CAV TOOL – ADDITION JSP17-17

Public hearing at the request of CAV Tool for Special Land Use Permit, Preliminary Site Plan, and Stormwater Management Plan Approval. The subject property is located in section 26, north of Nine Mile Road and west of Heslip Drive and is zoned I-1 (Light Industrial). The applicant is proposing to construct a 1,800 square foot addition to an existing industrial building with associated site improvements. A special land use is required for uses adjacent to residential zoned property.

PLAN REVIEW CENTER REPORT

JSP17-17

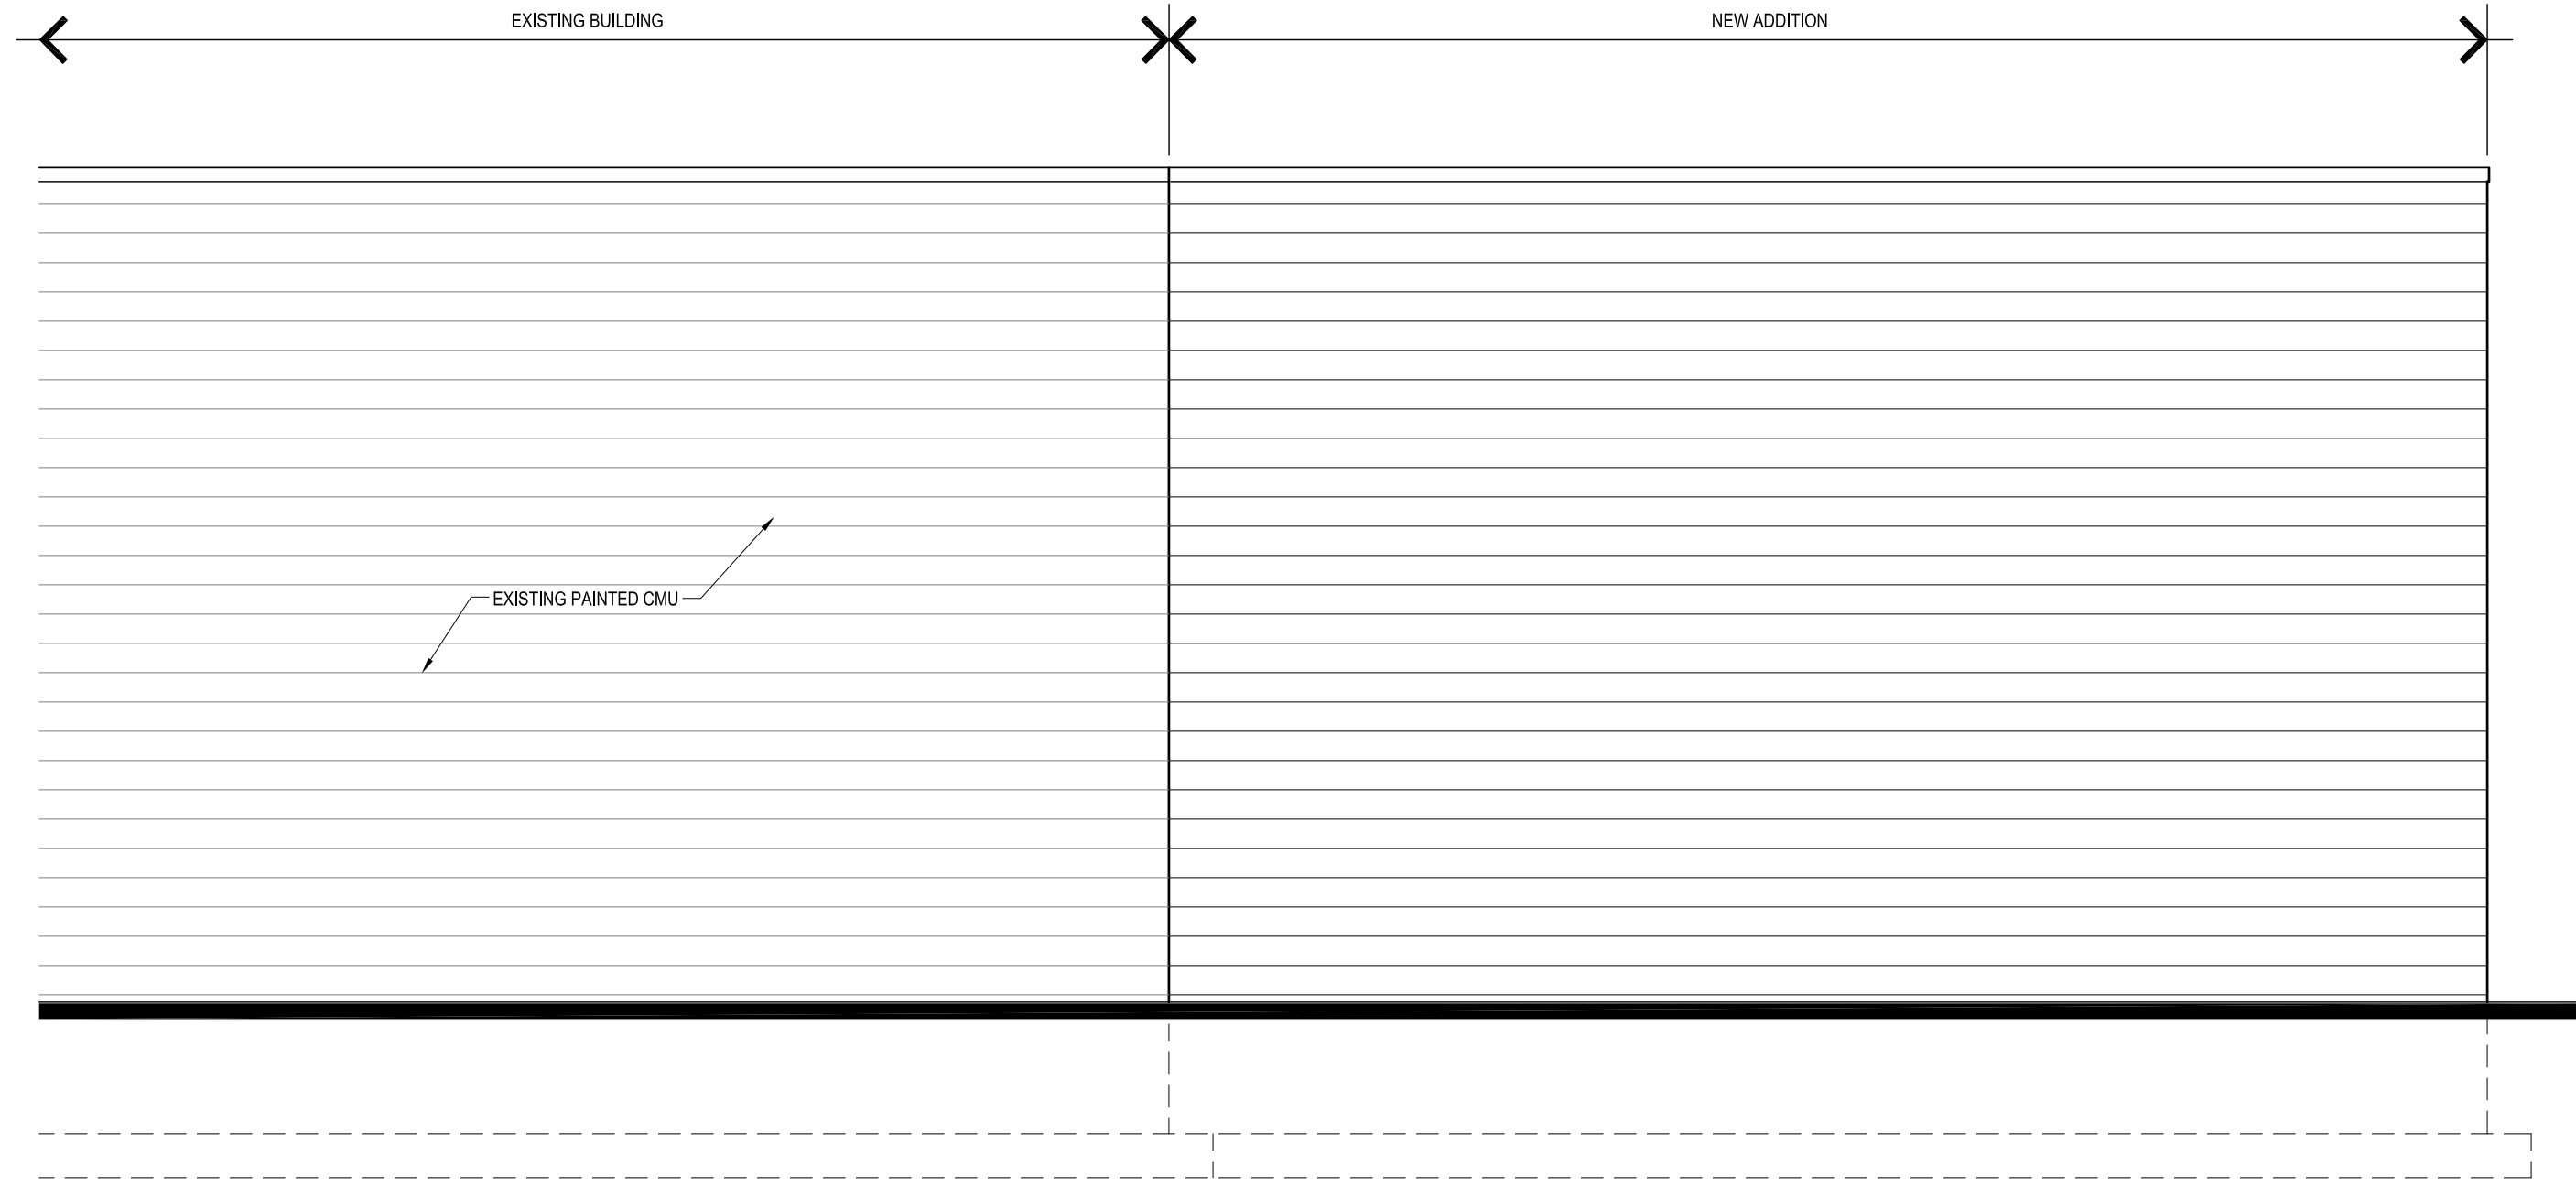
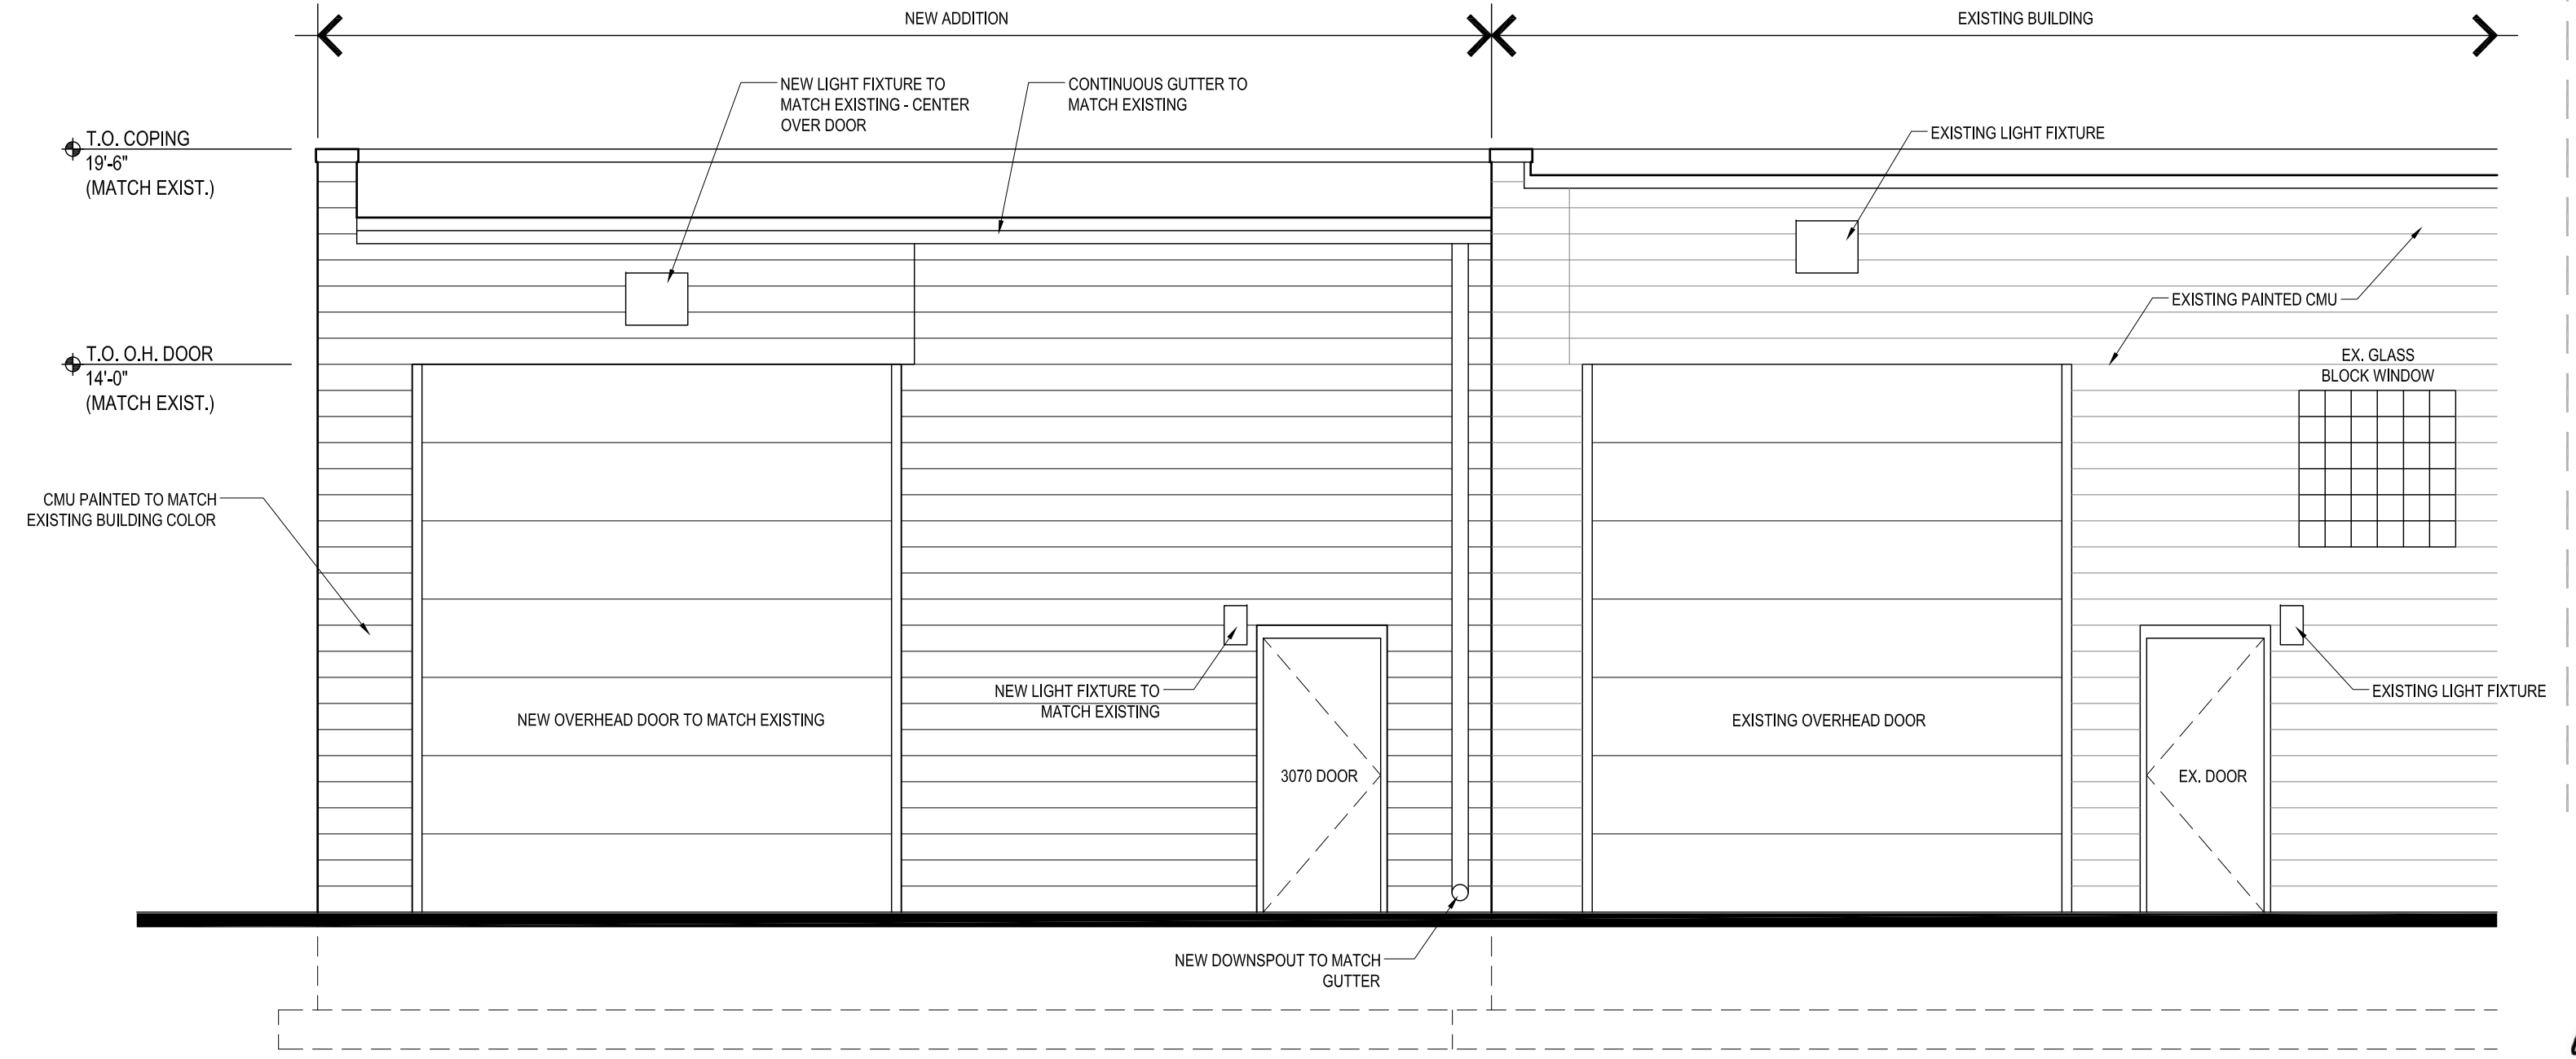
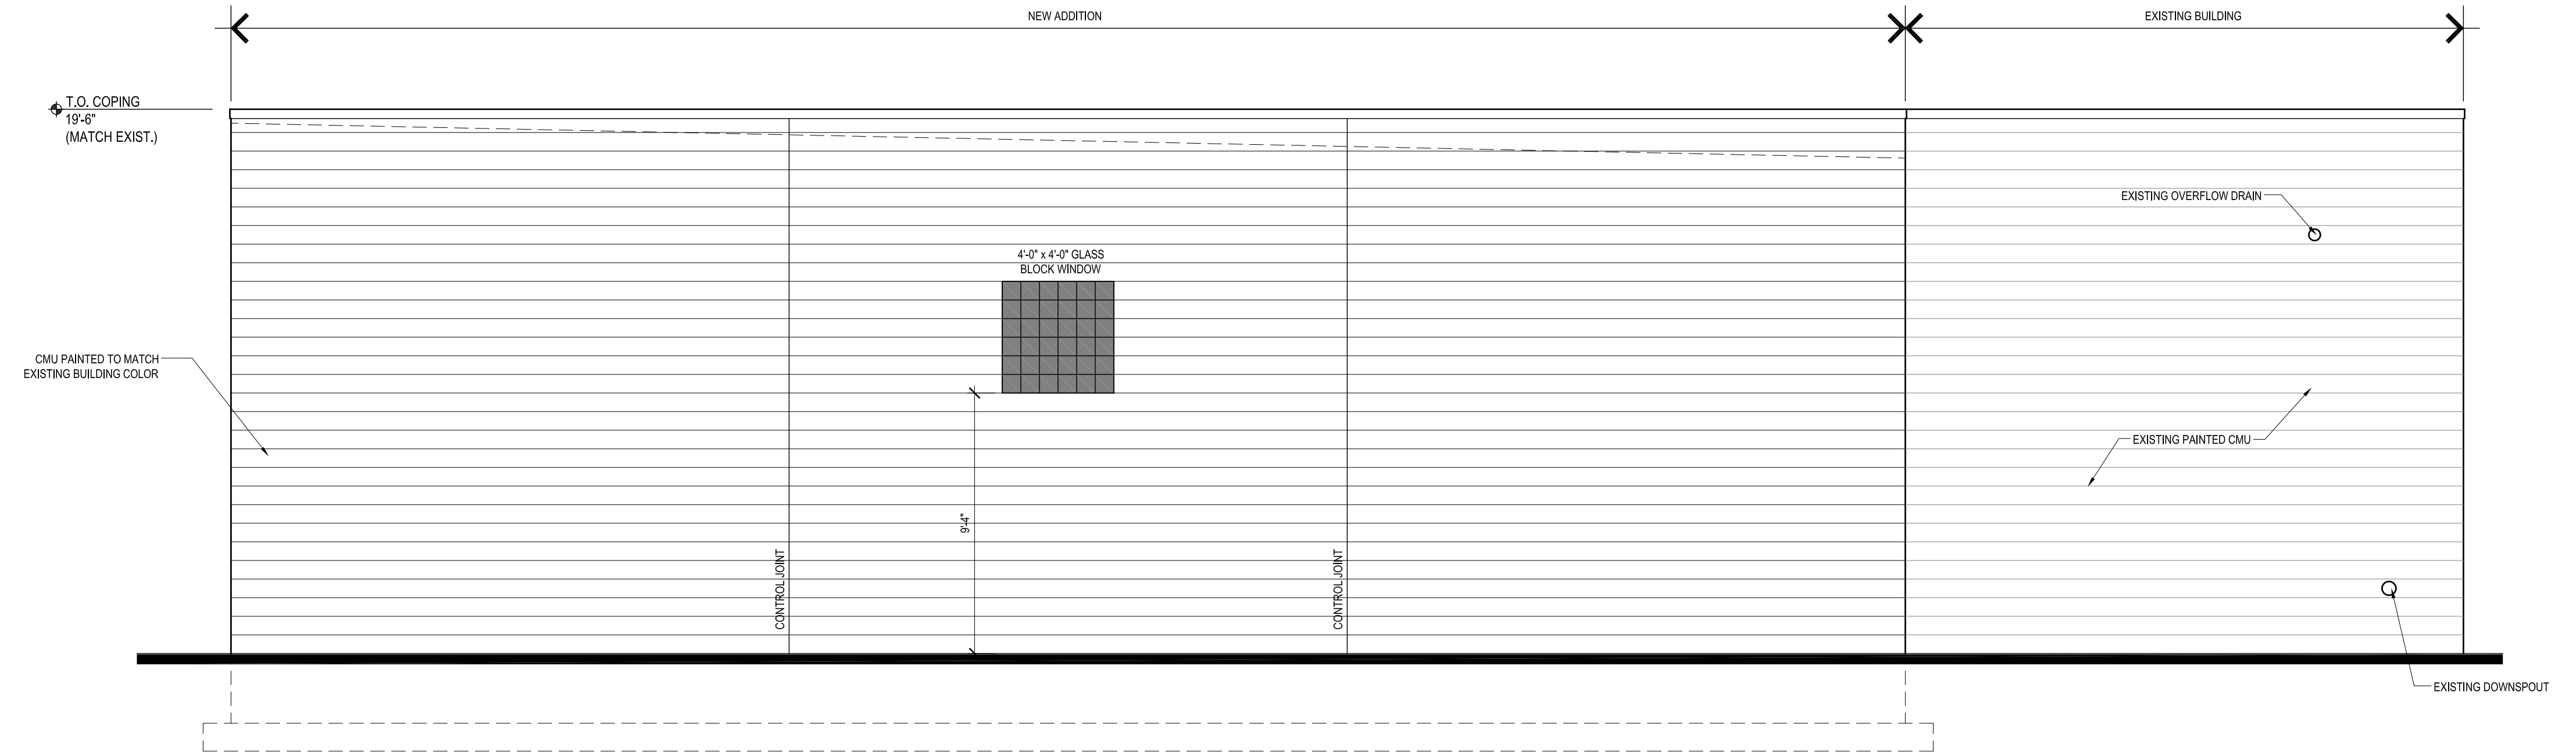
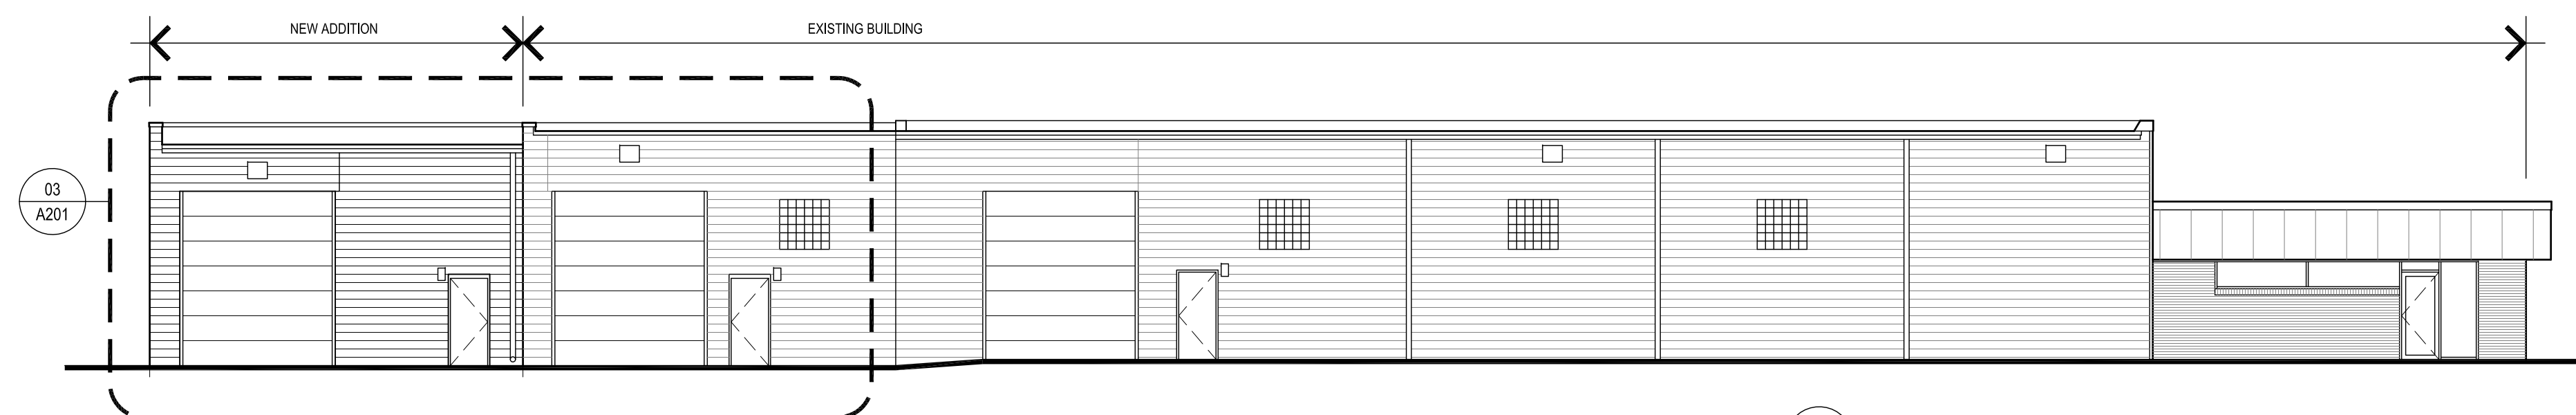
West	South	North	East	Ordinance Maximum (Minimum)
Plain Faced Concrete Masonry Units (CMU), Painted	100%	100%	Unaltered	Unaltered	0%

This project is considered an addition as described in Section 2520.7 of the Façade Ordinance. As shown above 100% Plain Faced Painted CMU is proposed. This material is not permitted by the Façade Chart. However Section 2520.7 permits a continuation of existing materials provided that the addition does not exceed 100% of the existing floor area, the new material substantially constitute a continuation of existing materials with respect to color, texture, size and height, and that and that the overall visual effect of the addition is to appear as part of the existing building. The proposed addition meets these conditions. **Therefore, the proposed design is in full compliance with the Façade Ordinance and a Section 9 Waiver is not required.**
